on behalf of **MURRAYLINK Transmission Partnership**

8 April 2003

Application for Conversion to a Prescribed Service and Maximum Allowable Revenue

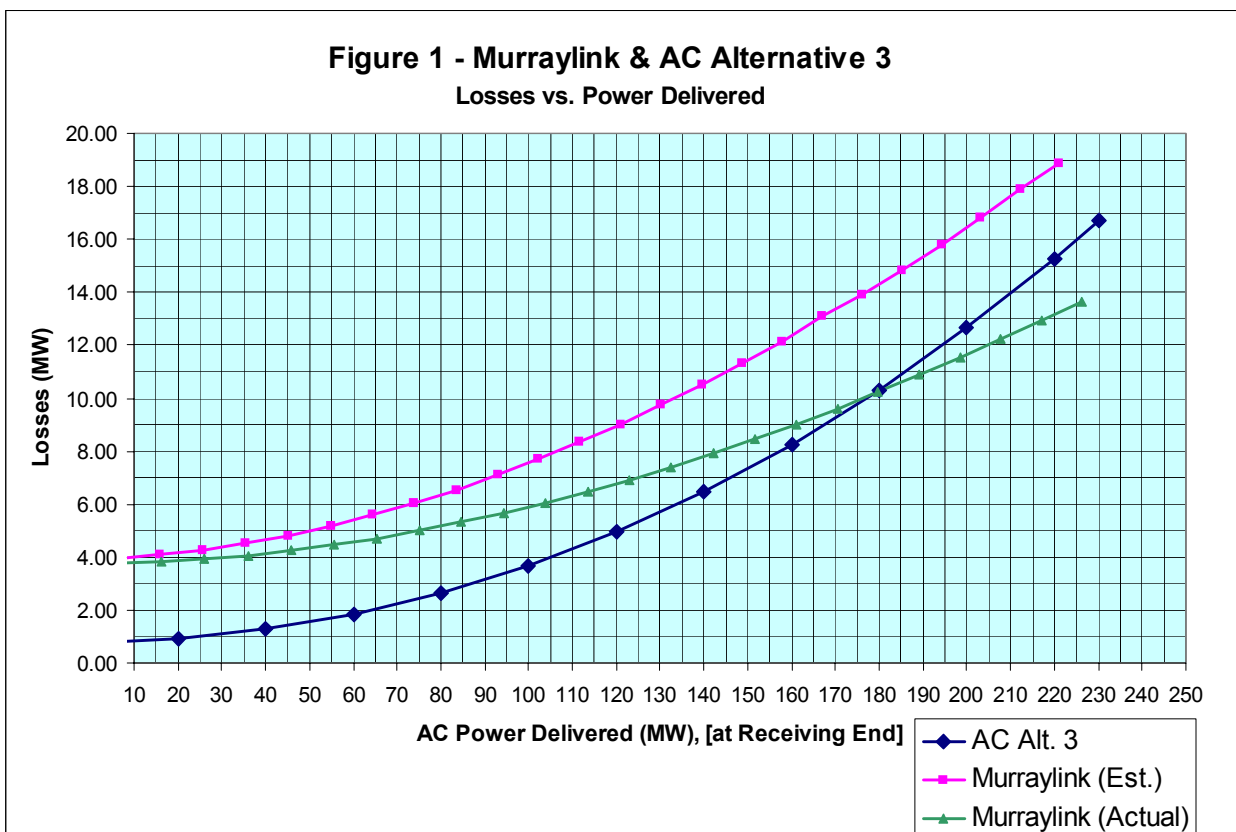
Loss measurements made after Murraylink began operations in 2002 have shown that actual losses are significantly lower than the estimated losses used in the market benefits modeling (see Figure 1 below). Consequently, the TEUS estimate of Murraylink market benefits is conservative. The benefit calculations have incorporated the impacts of intraregional and interregional losses in a consistent manner throughout. The losses ascribed to Murraylink are conservatively high, which will act to understate the total gross market benefits.

Figure 1 illustrates the results of the calculations summarized above. For each option, the corresponding curve shows transmission losses (MW) versus AC delivered end power (MW). The flow direction is from Victoria to South Australia, therefore, the delivered power is at the Monash 132 kV bus. Sending end power at the Red Cliffs 220 kV bus can be calculated by adding the transmission loss to the delivered power at any point on a given curve. As shown, the actual measured losses over the Murraylink project are significantly less than the initial estimated losses, especially for higher power transfer levels. This is primarily due to lower actual converter station losses as compared to the estimated values provided by ABB.

In comparing the estimated AC Alternative 3 losses to the actual Murraylink losses, the AC alternative losses are less at low power levels, however, for high power transfers, the losses are less for Murraylink. The crossover level for equivalent losses between the two options is approximately 176 MW of delivered power. At 220 MW delivered, AC Alternative 3 estimated losses are 16% higher than the actual calculated losses over Murraylink. During periods of high power transfer over the interconnector, where network reliability will often be most crucial, incremental transfers over Murraylink will incur less loss as compared to AC Alternative 3.
